Access Compliance Report

Public Rights-of-Way

(Curb Ramps)

Intersection ID: 44907	Main Street: OAK_DR	Cross Street: OAKWINDS_CT	Location: SE
ADA ID: 58463D74BD2E	Ramp Type: PerpDiag	Initial Pass/Fail: Fail	Overall Compliance: No
Severity Score: 21.25			
Codes/Mitigation Info/Possible Solution		Field Measurements/Component Compliance

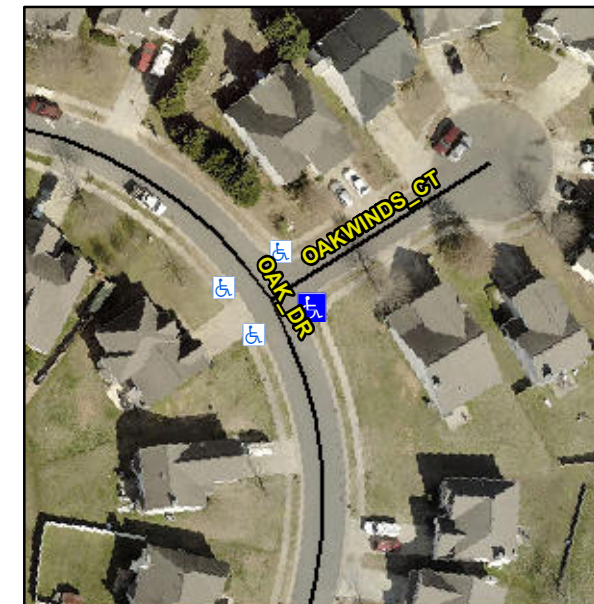
Not Found, R304.5.1, R304.2.2

Compliance	Description	Data	Compliance	Description	Data
N/A	Ramp Length (in)	47.0	No	Ramp Slope (%)	11.0
No	Ramp Width (in)	37.0	Yes	Ramp XSlope (%)	0.9
N/A	Flare Type LT	N/A	N/A	Flare Type RT	N/A
N/A	Flare Slope LT (%)	N/A	N/A	Flare Slope RT (%)	N/A
N/A	Flare Traversable LT?	N/A	N/A	Flare Traversable RT?	N/A
N/A	Landing Length (in)	N/A	N/A	DWS Provided?	N/A
N/A	Landing Width (in)	N/A	N/A	DWS Contrast?	N/A
N/A	Landing Slope (%)	N/A	N/A	DWS Length (in)	N/A
N/A	Landing X Slope (%)	N/A	N/A	DWS Full Width?	N/A
N/A	Landing Curb? (Y/N)	N/A	N/A	DWS Offset (in)	N/A
N/A	Shared Landing?	N/A			
N/A	Gutter Ponding?	N/A	N/A	Gutter Slope (%)	N/A
N/A	Gutter Lip Ht (in)	N/A	N/A	Gutter X Slope (%)	N/A
N/A	Painted X Walk1?	No	N/A	Painted X Walk2?	No
	X Walk 1 Direction	To NW		X Walk 2 Direction	To SW
N/A	X Walk 1 Width (in)	N/A	N/A	X Walk 2 Width (in)	N/A
	X Walk 1 Slope (%)	1.2		X Walk 2 Slope (%)	2.5
	X Walk 1 X Slope (%)	2.3		X Walk 2 X Slope (%)	1.9

Remove & Replace Curb Ramp With Two New Directional Ramps or Equivalent.
